UN Regulation No. 48 (Installation of lighting and light-signalling devices):

Proposal for a Supplement to the 06 and 07 series of amendments to UN Regulation No. 48

Submitted by the expert from the International Organization of Motor Vehicle Manufacturers*

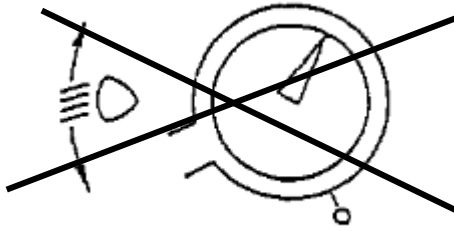
A rotary control that is installed edge on, or with only the edge visible, should follow the operating principles of control of types (a) or (c).
 - 1.1.1. This control shall carry symbol(s) indicating clearly the movements corresponding to the downward and upward inclination of the dipped beam.
 - 1.2. The "0" position corresponds to the initial inclination according to paragraph 6.2.6.1.1. of this Regulation.
 - 1.3. [The marks used on control shall be explained in the owner's handbook.]
 - 1.4. ~~Only the following symbols may be used to identify the controls:~~

Symbols employing five lines instead of four may also be used

Example 1:

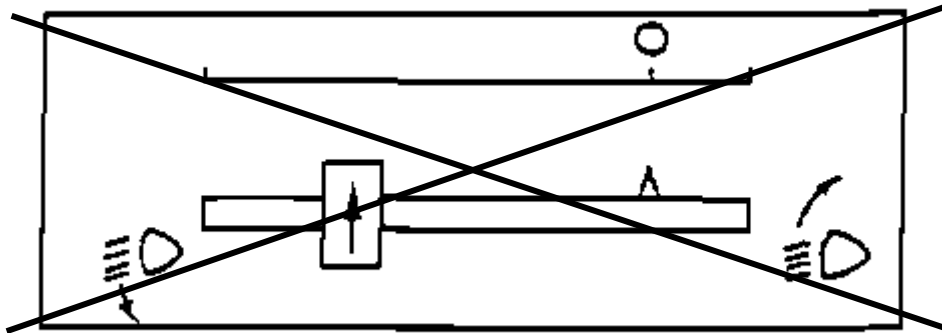
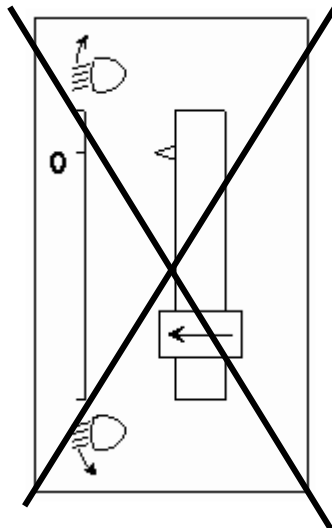
8. 'Downward' should be deleted. In the old text it referring to the direction of the control device. For trucks we are adjusting the dipped beam both upwards and downwards due to different loading characteristics of different vehicle configurations.
 9. In order for the requirements to be technology neutral, the prescription of control methods (downwards, rotary, push-pull) have been deleted.
 10. Requirement 1.3 referring to the owner's handbook has been moved into the main regulatory text (see paragraph 6.2.6.2.2.5.) and therefore can be deleted.
 11. Requirement 1.4. specifying the symbols, which can be used, has been deleted as these are already prescribed in UN Regulation No. 121.
 12. Examples of controls 1, 2 and 3 have been deleted as the illustrations are considered outdated.
-
